Product Update Gearmotor Division

February 1, 2022

Notification on Change for Terminal Box & Cable Strain

Illustration of Changes

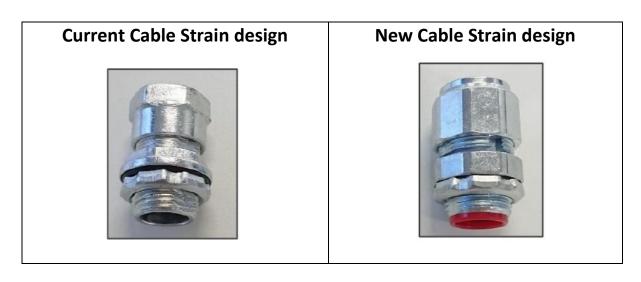
As a result, we are making a change in specific types of gearmotor cable strains/glands as well as some terminal boxes. This specifically affects Gear motor types listed below.

SERIES	Capacity	Specs for Terminal	Revision Status	
		Box	Cable Gland	Terminal
INDUCTION MOTORS	1/50-1/10Нр	A-BOX	YES	NO
		Z-BOX		
	1/8-3Hp	A-BOX	YES	NO
		E-BOX	YES	YES
IPM GEAR MOTORS	1/8-3Hp	E-BOX	YES	YES

Dimensional Comparison of Changes

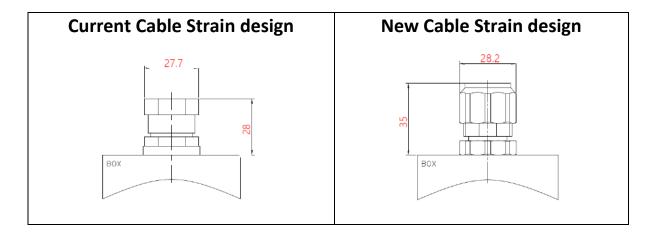
Cable Strain/Gland Changes:

- Induction Gearmotors
 - o 1/50Hp-1/10Hp (15W-90W)
 - A-Box
 - Z-Box
 - o 1/8Hp-3Hp (0.1kW-2.2kW)
 - A-Box
 - E-Box
- IPM Gearmotors
 - 1/8Hp-3Hp (0.1kW-2.2kW)
 - E-Box

E-Type Terminal Box Changes

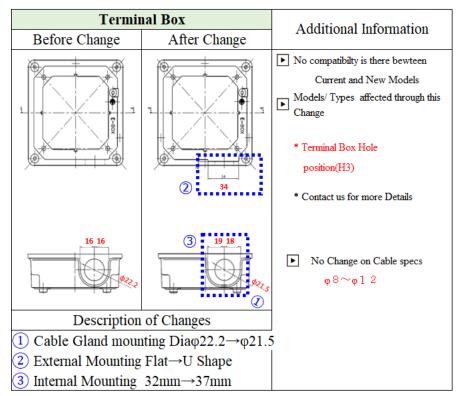
Terminal Box Changes

- Induction Gearmotors
 - 1/8Hp-3Hp (0.1kW-2.2kW)
 - E-Box
- IPM Gearmotors
 - 1/8Hp-3Hp (0.1kW-2.2kW)
 - E-Box

- The above Mentioned changes will be effective on orders received from May 2022.
- Running change based on availability of parts.
